ROOFTOP

RTU 1 - KITCHEN

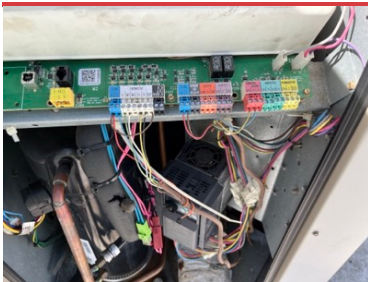
Grease discharge is causing maintenance issue for RTU & will degrade life of unit. Recommend installing a galvanized discharge duct on fan. Route 18" vertical before directing 45 degree on low side & go at least 12" to 18" on short side of 45"

RTU 1 RETURN

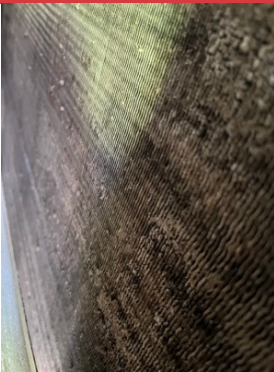
Inside Mixed air plenum prior to Dx Coil. Make sure return duct & curb adapter are sealed properly for no leakage

RTU 2 RETURN

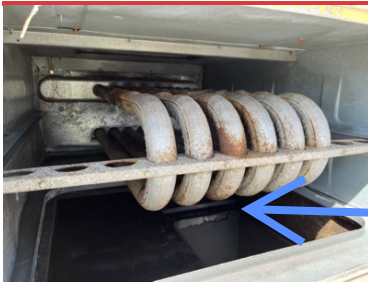
Ensure return duct & curb adapters are sealed tightly to prevent leakage

RTU 2 CURB ADAPTER (DISCHARGE SIDE)

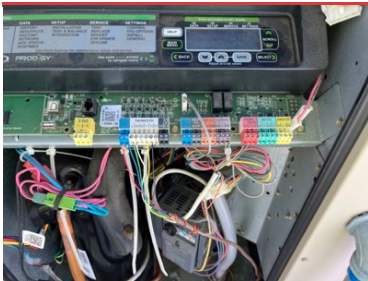
Return duct is not sealed to adapter, need to seal better to units & ensure adapter to unit is also sealed properly.

Both units supply ductwork is not sealed to curb adapter causing leakage directly at unit. This will cause lower airflow readings down in the space.

ATYPICAL RETURN GRILLS

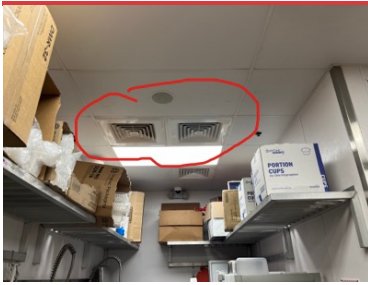
These grills are typically used for supply air

No impact on TAB or comfort. Just for FYI so no confusion on location of return grills

THERMOSTATS

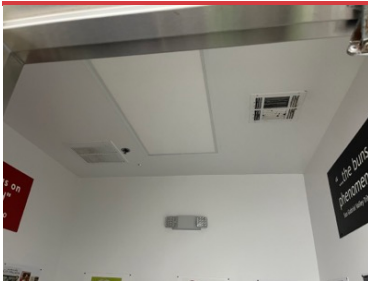
NTAB changed fan function to “Fan ON” to maintain building pressure. Previously set to “Auto”
